RENESAS TECHNICAL UPDATE

Product Category	MPU/MCU		Document No.	TN-RX*-091A/E	Rev.	1.00
Title	Corrections to the RX111 Group User's Manual: Hardware regarding Communication Protocol of the Flash Memory		Information Category	Technical Notification		
Applicable Product	RX111 Group	Lot No.	Reference Document	RX111 Group User's Manual: Hardware Rev.1.00 (R01UH0365EJ0100)		
		All

This document describes corrections to descriptions for communication protocol of the flash memory in RX111 Group User's Manual: Hardware.

Figure 35.16 Procedure to Select the Device and Change the Bit Rate is corrected as follows:

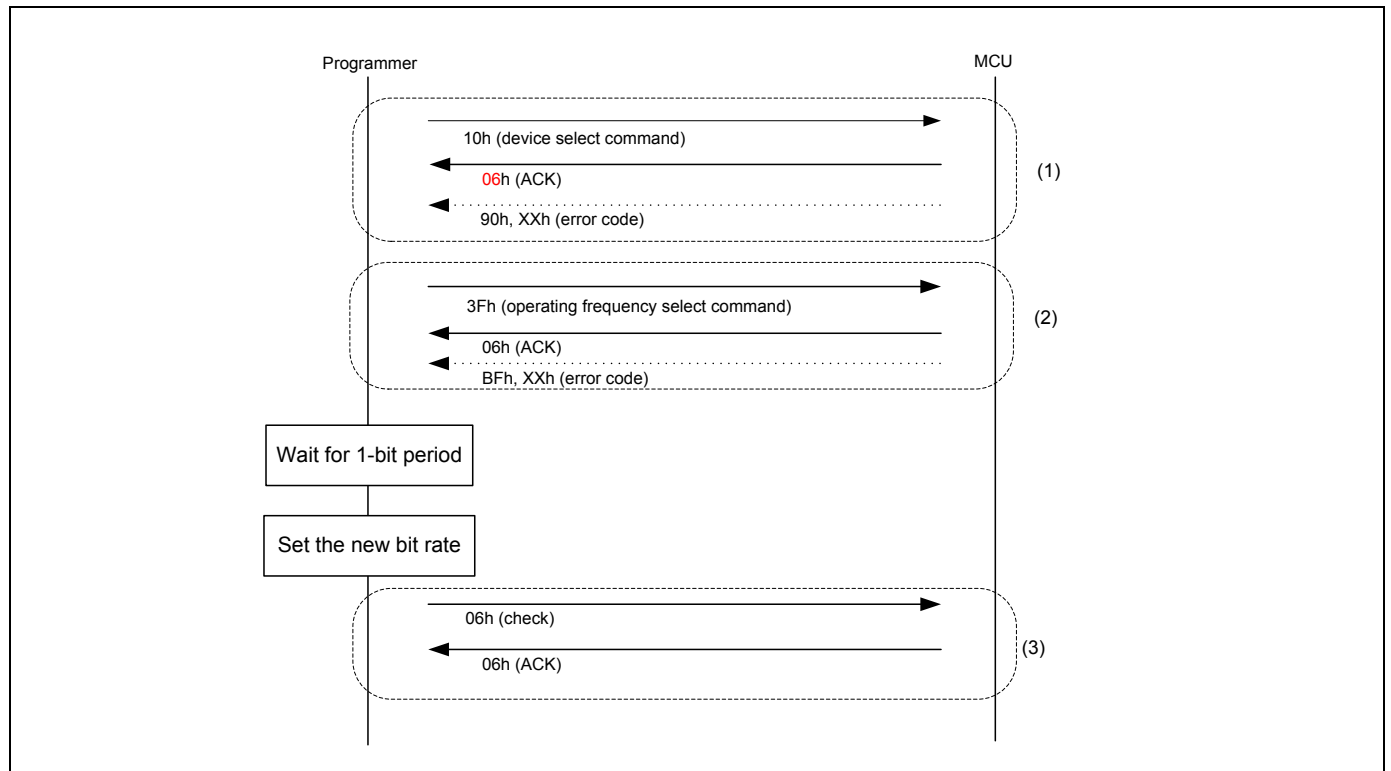
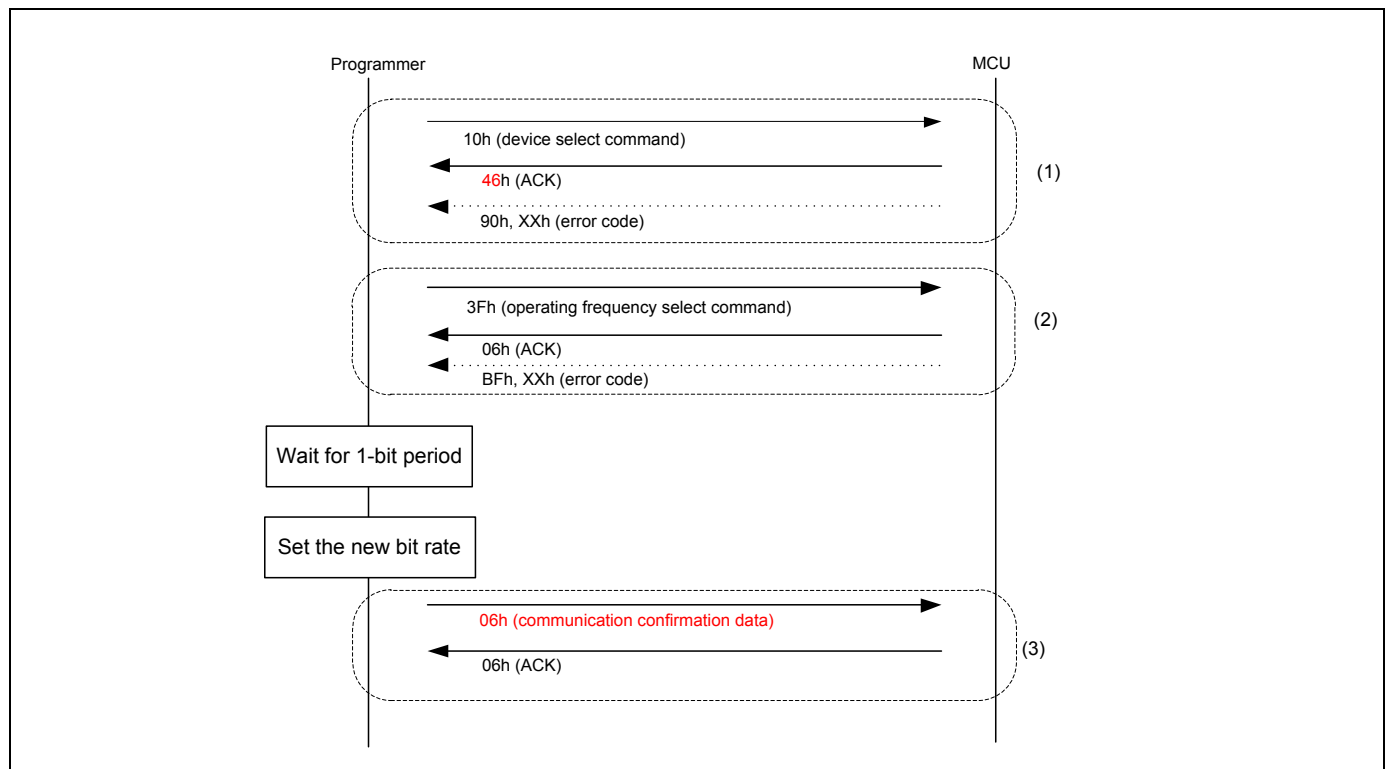
- (1) Send the device select command (10h) to select the device to connect with the programmer and the endian of data that is programmed. When the program data is little endian, select the same device code as that for little endian in the response to the support device inquiry command. When the program data is big endian, select the same device code as that for big endian in the response to the support device inquiry command. When the device is selected successfully, the MCU sends a response (46h). When the MCU fails to receive, the MCU sends an error response (90h).

- (3) When **the programmer** receives a response (06h), the MCU waits for 1-bit period at the bit rate for sending the operating frequency select command, and then set the bit rate of the programmer to the changed value. After that, the MCU sends communication confirmation data (06h) at the changed bit rate. When the MCU receives the command successfully, the MCU sends a response (06h) of the communication confirmation data.

Figure 35.19 Procedure to Send Commands in Erase Ready Operation is corrected as follows:

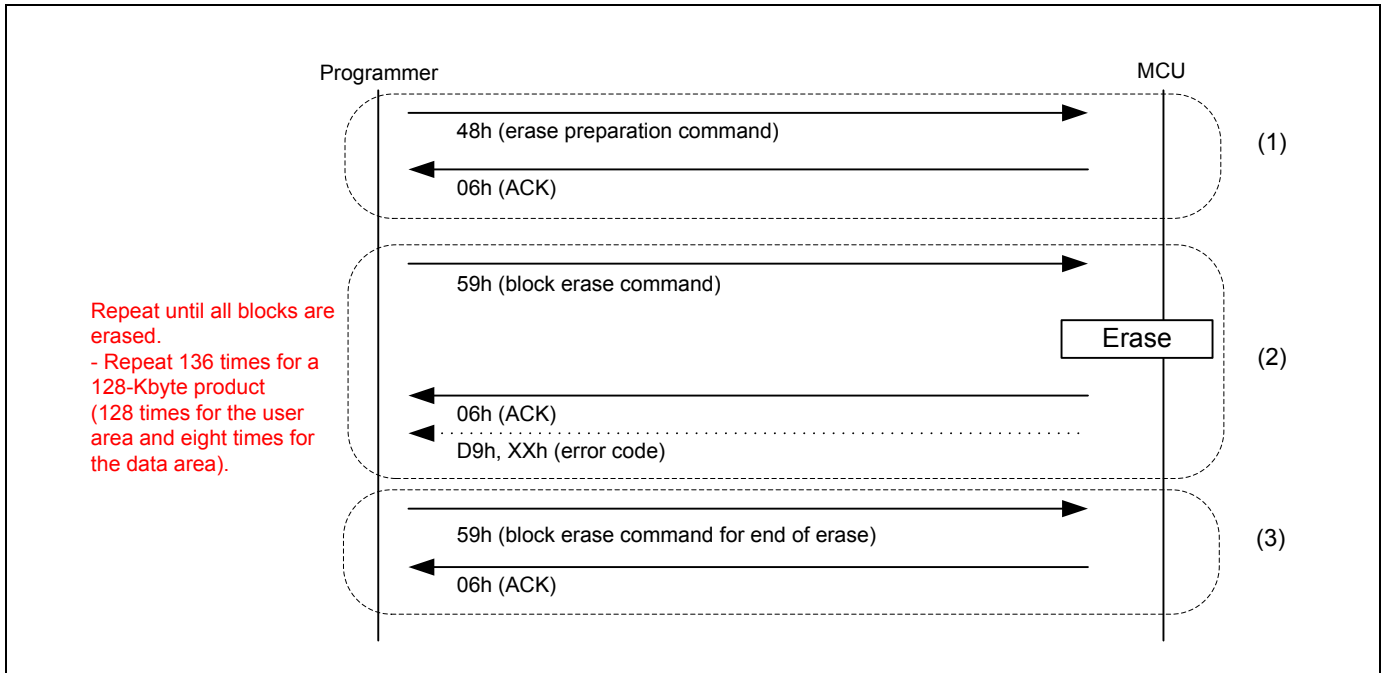
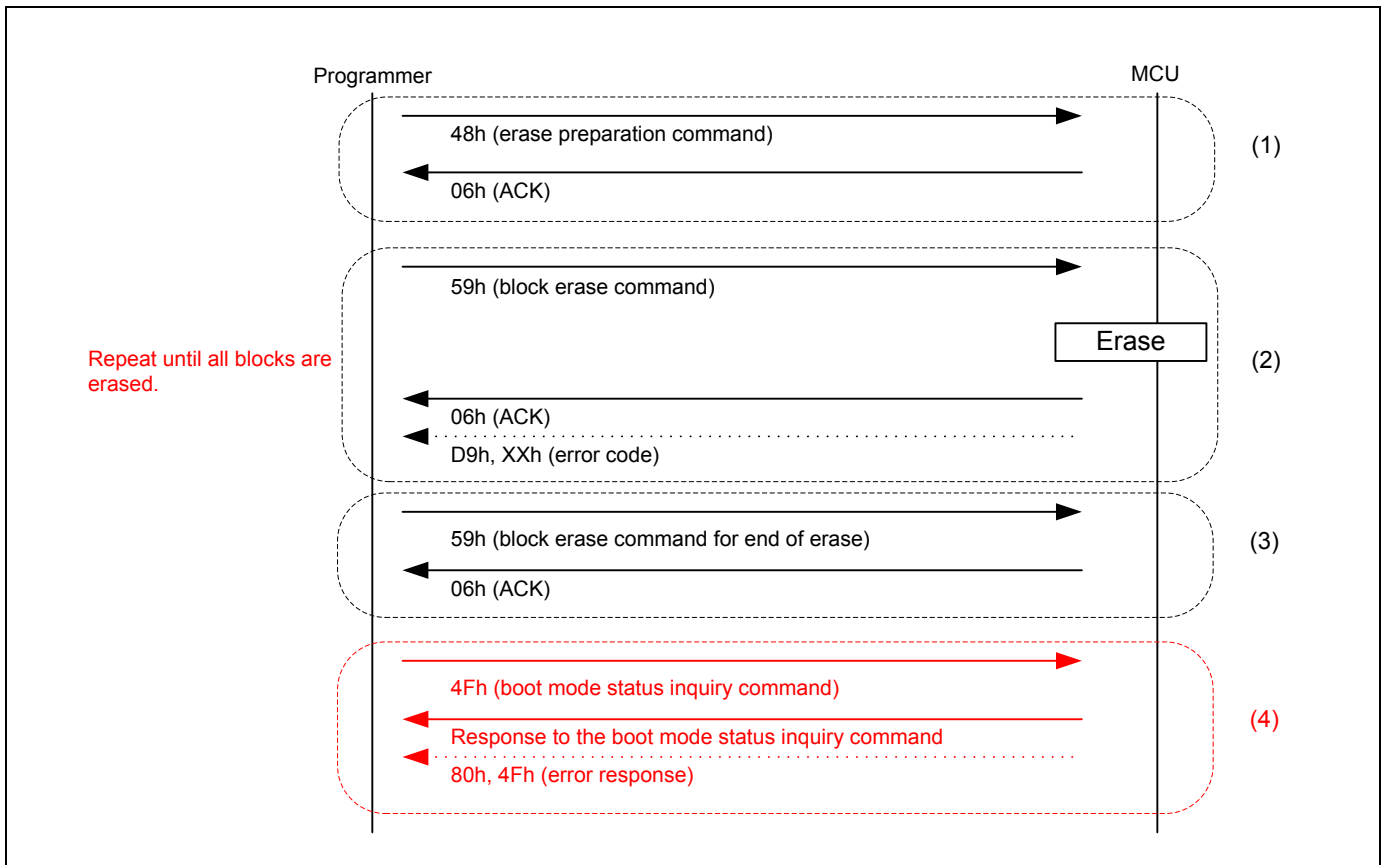
Send block erase commands repeatedly until a block erase command has been sent for the total number of blocks. The total number of blocks is the sum of the user area blocks and data area blocks that are obtained in advance using the block information inquiry command. If the operation ends before all the block erase commands are sent, a command error may occur even when a correct command is sent in the program/erase state.

(3) Send a block erase command for end of erase (59h 04h FFh FFh FFh FFh A7h). The MCU sends a response (06h).

(4) To confirm whether erase ready operation has ended, send a boot mode status inquiry command (4Fh). When the erase ready operation has ended, the MCU returns the result of the boot mode status inquiry. When the erase ready operation has not ended, the MCU sends an error response (80h 4Fh). When an error response is received, restart the MCU in boot mode and perform the procedure again from section 35.9.10.1, Bit Rate Automatic Adjustment Procedure.
